DOCKET ITEM #9
Development Special Use Permit # 2014-0005
Marino's Restaurant – Extension
3100 Jefferson Davis Highway (Parcel Address: 3104
Jefferson Davis Highway)

Purpose of Application: Request for an 18 month extension for an approved Development Special Use Permit with Site Plan. (DSUP #2010-0004)

DSUP #2014-0005
3100 Jefferson Davis Highway
Parcel Address: 3104 Jefferson Davis Highway

Proposed Front Elevation

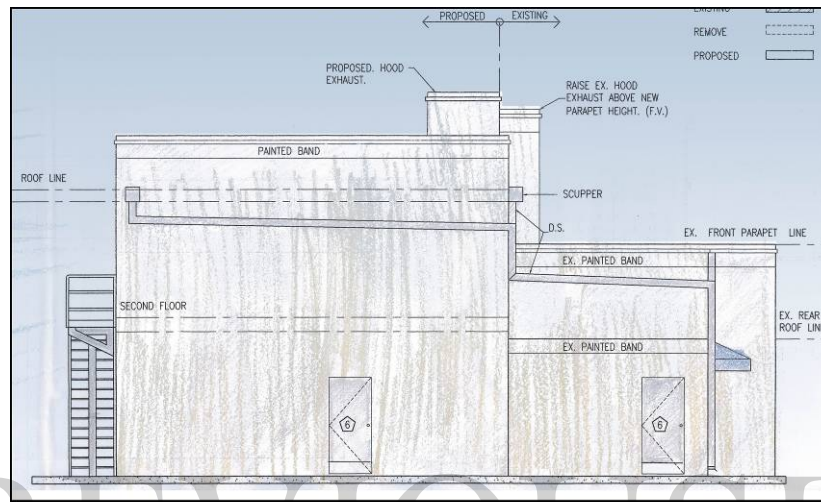
- a. building plans and elevations that accurately reflect existing and proposed conditions, including but not limited to: roofline hood exhausts, HVAC units, screening devices, exterior material finishes, signage, concrete walks, all door and gate swings. (P&Z)

12. Color architectural elevations shall be submitted during final site plan review.
13. Per the City's Green Building Policy adopted April 18, 2009, incorporate green building design elements at final site plan to the satisfaction of the Directors of P&Z, RP&CA and T&ES.* (P&Z, RP&CA and T&ES)
14. **CONDITION AMENDED BY STAFF:** In order to provide a more sustainable use of natural resources, the applicant shall use EPA-labeled WaterSense or equivalent low flow fixtures, to minimize the generation of municipal wastewater from the site and ~~In addition, the applicant is encouraged to explore the possibilities of adopting water reduction strategies (i.e., use of gray water system on-site) and other measures that could possibly reduce the wastewater generation from this site.~~ A list of applicable mechanisms can be found at <Http://www.epa.gov/WaterSense/pp/index.htm>. (T&ES)

Site plan

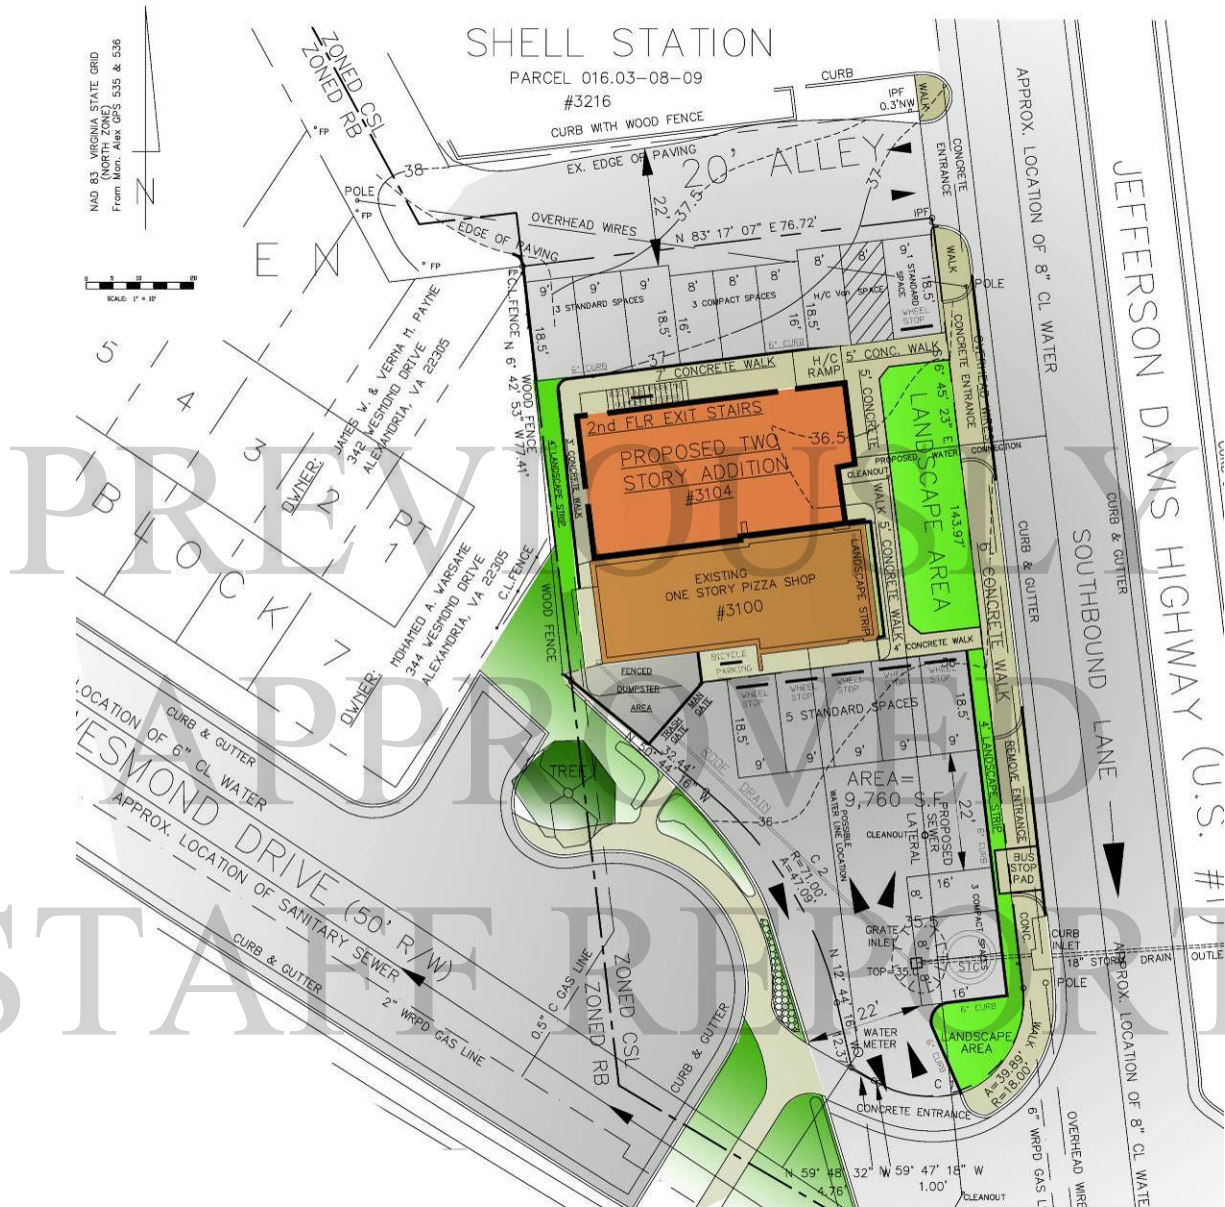
1. **CONDITION AMENDED BY STAFF:** The Final Site Plan shall be in substantial conformance with the preliminary plan dated November 15th 2010 (including supplemental information dated December 13th 2010, ~~and~~ the revised parking layout agreed with ~~the~~ City staff 24th January 2011 shown in Attachment #1), and the landscape plan agreed with City staff 31st July 2012 shown in Attachment #2) and comply with the following conditions of approval.

10. The area of the limits of disturbance and clearing for the site shall be limited to the areas as generally depicted on the preliminary site plan dated 11/15/10 (revised as agreed with the City 24th January 2011) and reduced if possible to retain existing trees and grades.
(P&Z and RP&CA)
